SUBJECT: Calvert Cliffs Nuclear Power Plant
Unit Nos. 1 & 2; Docket Nos. 50-317 & 50-318
License Amendment Request: Modification of Containment Closure During
Core Alterations/Fuel Handling and Loss of Shutdown Cooling

Attachments: (1) Background and Analysis
(2) Determination of Significant Hazards
(3) Technical Specifications Marked-Up Pages
(4) Illustration of Equipment Hatch Opening
(5) Illustration and Description of the New Containment Outage Door Assembly

**ILLUSTRATION OF
EQUIPMENT HATCH OPENING**

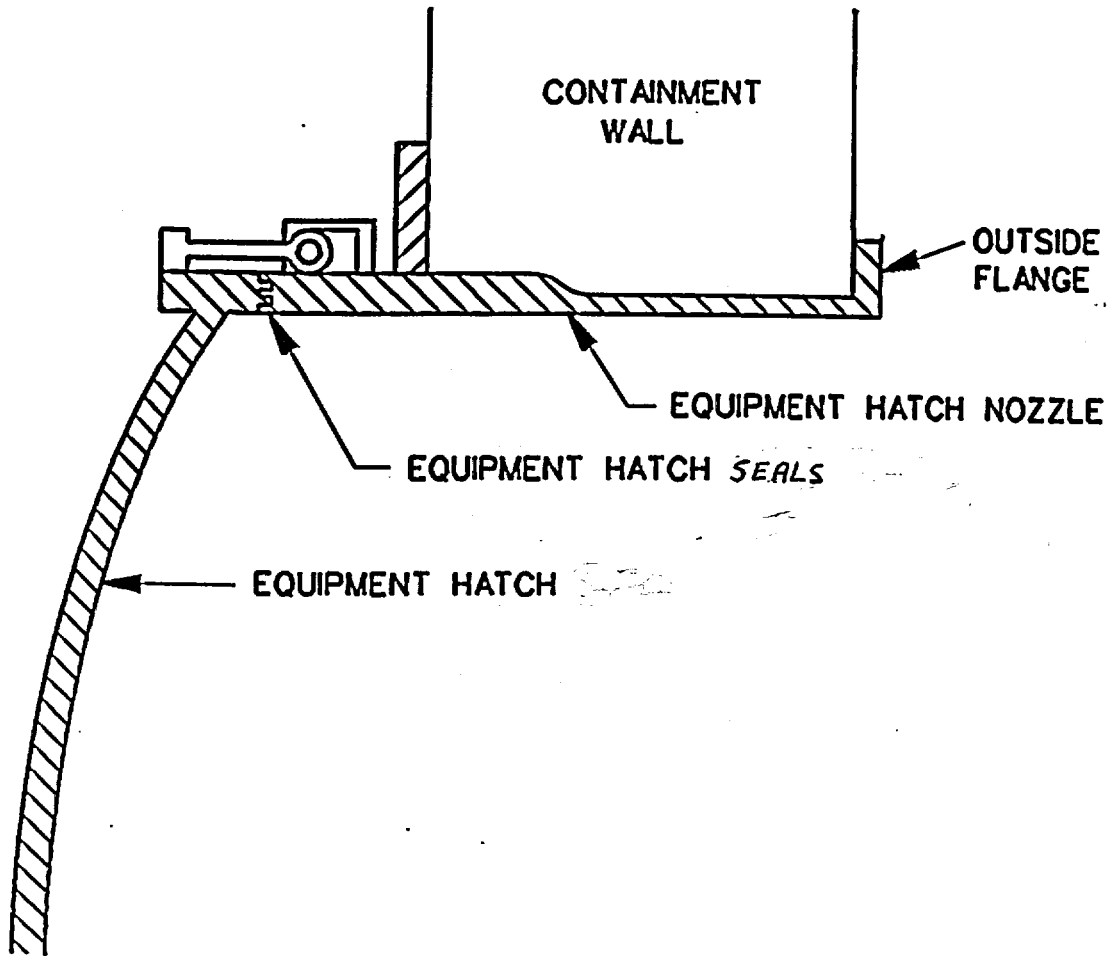
1. The containment equipment hatch opening is a 19-foot circular opening in the side of the Containment leading directly to the outside environment at ground level (45 feet above sea level). The structure surrounding the opening is composed of a circular steel nozzle equipped with flanged surfaces on the inside and outside of Containment (a drawing is provided in Attachment 4). The purpose of the containment equipment hatch opening during Modes 5 and 6 is to allow personnel and equipment movement into and out of the Containment. Currently the Technical Specifications require that the equipment hatch opening be closed during certain outage evolutions, such as core alterations/fuel movement and maintenance on the SDC System. Closing the equipment hatch opening restricts equipment movement into and out of Containment, and slows other outage work.

The device that closes the equipment hatch opening is called the equipment hatch. Closing the equipment hatch provides containment integrity during power operation (Modes 1 - 4), and currently provides containment closure during reactor shutdown (Modes 5 and 6). The equipment hatch is a solid, round flange weighing approximately 13 tons that, in its shut position, is mounted on the inside of the equipment hatch opening. It is built to withstand a pressure in Containment of 50 psig, the pressure postulated to result from a loss-of-coolant accident. When open, the equipment hatch is stored above the equipment hatch opening. Currently, when the equipment hatch opening must be closed during an outage, the equipment hatch is lowered with an electric winch and secured with at least four bolts. This process takes 1 to 1-1/2 hours.

The steel containment outage door assembly (shown in Attachment 5) will be installed on the outside of the containment equipment hatch opening. The operational part of the assembly is a hinged door that can be sealed in the closed position by handwheel-operated dogs. The door is sized to allow the passage of the reactor coolant pump motor on a trailer. The door assembly is designed to withstand a containment pressure of 12 psig, and will be tested for its capability to close and seal prior to being placed in service. The containment outage door frame is designed with flange connections that will allow the passage of hoses and cables into Containment. These penetrations on the containment outage door frame will be closed by either a blind flange or with a cable or hose fitting that will withstand a containment pressure of 12 psig. Currently, the temporary closure device installed in the emergency air lock provides this function. After the changes proposed in this request are approved, we will not need to install the temporary closure device in the emergency air lock during routine outages. However, there may be situations where we would need or desire to use the temporary closure device. Therefore, this license amendment will not delete the Technical Specification wording allowing use of the temporary closure device.
